The Corporation of the District of Saanich

Subject: 5229 Cordova Bay Road - Development Permit Amendment

File: DPA01077

Figure 4. Proposed north elevation – Fenn Avenue frontage.

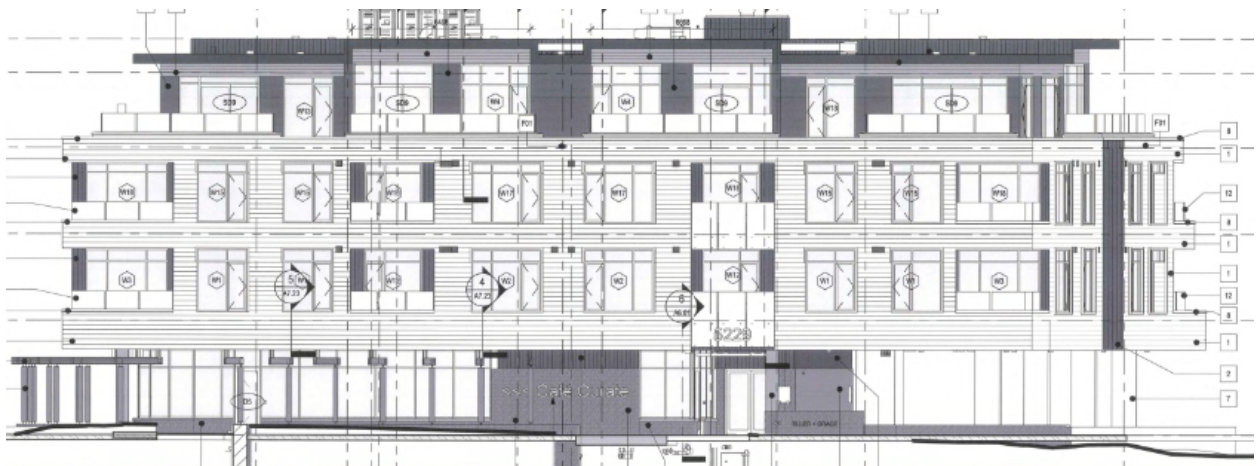
This application is proposing the addition of an overhead vehicle gate, and a fence with pedestrian gates, to provide secured access to the building's parking area. This change would affect the Form and Character of the development and has been referred to Council for decision. The Site Plan (changes in red bubbled areas) and before-and-after elevations are shown below in Figures 2 through 6.

The overhead vehicle gate will remain open during business hours. Patrons of the commercial space can park in designated spaces in the under-building parking during business hours. Pedestrian gates will be able to open during business hours, and will be equipped with accessible, push-button openers.

After business hours, the overhead gate will close. Residents will be able to enter through the vehicle overhead gate using a remote opener, and visitors with a vehicle will have to coordinate with residents to be granted access through the overhead gate. As well, after business hours, the pedestrian gates will lock. Residents can use these gates with a fob. Visitors on foot can be admitted through the main residential entrance by using a call panel/intercom system, and would not need to access any of the pedestrian gates.
